<< NOTE FROM BOB SULTAN: This document supplies additional text and modified figures for portions of 802.1Qbg subclause 41.1.8 for the resolution of comment #738 (<http://www.ieee802.org/1/files/private/bg-drafts/d1/802-1Qbg-D1-3-dis-v1.pdf>). This material is also in the slides <http://www.ieee802.org/1/files/public/docs2011/bg-gu-pcp-in-vdp-rsp-0111-v02.ppt> presented at the January 2011 interim meeting. Features added are:

#### 41.1.8 Filter Info field

Figure 41-2—VID Filter Info format

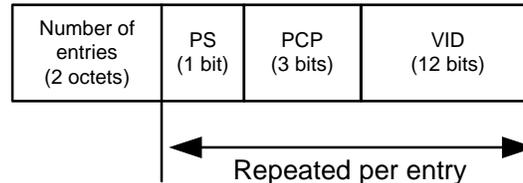
- 1) A Priority Code Point (PCP) value can accompany any, or all, VID values specified in a VDP Response;
- 2) The 2-octet field of the VDP TLV that was called the VID field is no longer called the VID field and is replaced by a 1-bit PCP Significant (PS) field, a 3-bit PCP field, and a 12-bit VID field;
- 3) A PS field having the value zero indicates that the PCP field that follows does not contain a significant value of PCP;
- 4) The value of the PCP field, when significant, is adopted by the EVB Server as the 'default PCP' value associated with the specified VSI and VID;
- 5) Data frames sent by the EVB Server towards the EVB Bridge associated with the specified VSI and VID carry the 'default PCP' value unless another PCP value is explicitly specified;
- 6) This description is based on the text of D1.3; it does not include other comments made during D1.3 comment resolution; >>

<< Note that in the following subclauses *only* the figures 41-2 through 41-5 have been modified. No text has been modified (as indicated by the change bars).>>
